FACILITY COMPLIANCE AUDIT REPORT
Division of Waste Management
Solid Waste Section

FACILITY NAME AND ADDRESS:
R&R Farms LCID Landfill
Sparrowhawk Lane
Newport, NC 28570

PURPOSE OF AUDIT:
Follow up audit

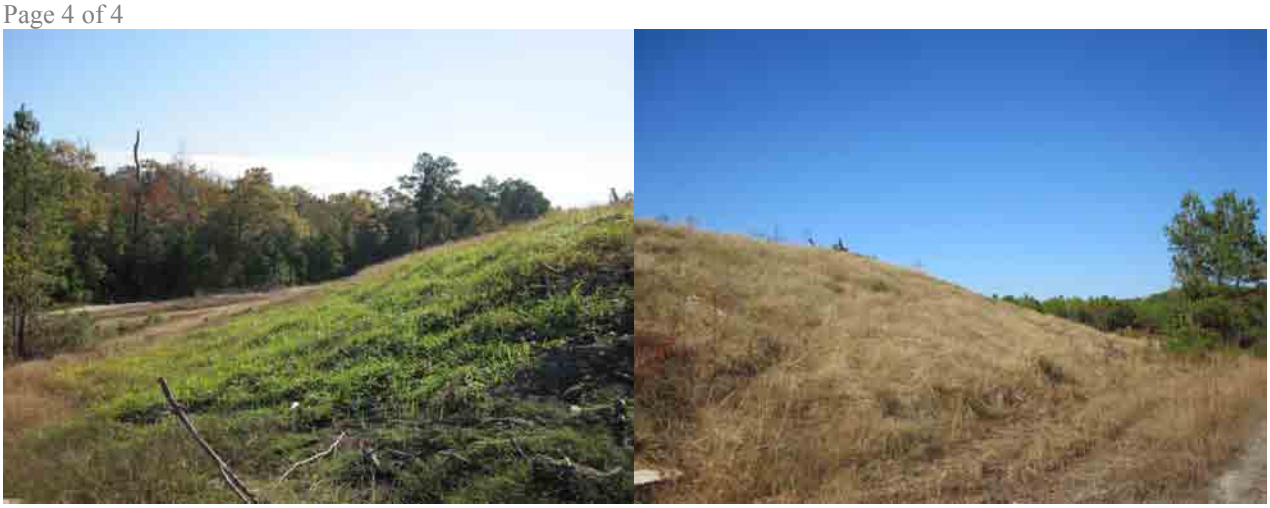
Areas on sideslope needing continued attention: cover, grading, and seeding necessary

Soil stockpiled for cover behind landfill Compact working face

Improved sideslopes with suitable cover and proper grade
